**TENTATIVE AGENDA
NOVEMBER 13, 2024 6:30 PM.
ARCHITECTURAL REVIEW BOARD**

**REVIEW OF PLANS FOR COVERED PATIO ADDITION–
Mark and Ellen Fesler, 7 Edwin Ave.**

A NEW OUTDOOR ROOM AND FINISHED BASEMENT FOR:
THE FESLER RESIDENCE

STORMWATER CONTROL PLAN - 7 EDWIN AVENUE GLENDALE MO 63122

OUTDOOR ROOM FIRST FLOOR AND ROOF PLANS
 Sheet Number:
A3

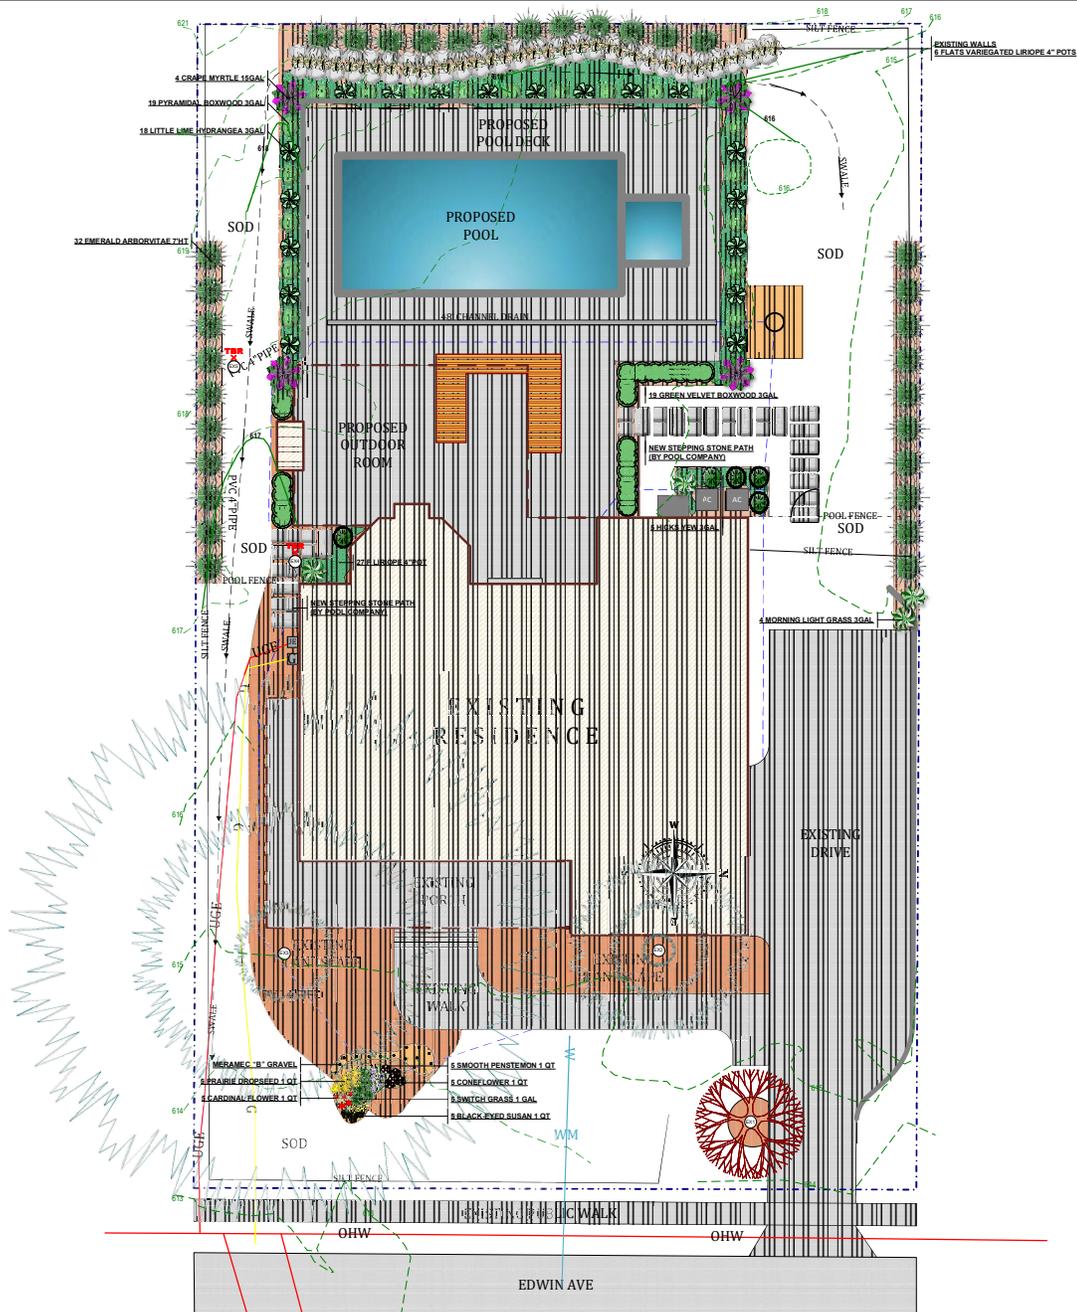
- Mr. Falk and Mr. Moran noted that downspouts and the water dispersal need to be marked on the plans.
- Mr. Voorhees discussed potential problems with the roof plan and the elevation of the cricket with respect to the new roof eave, and gutter. The Roof Plan needs to be corrected.
- The stormwater plan doesn’t show contours to show the flow of water.
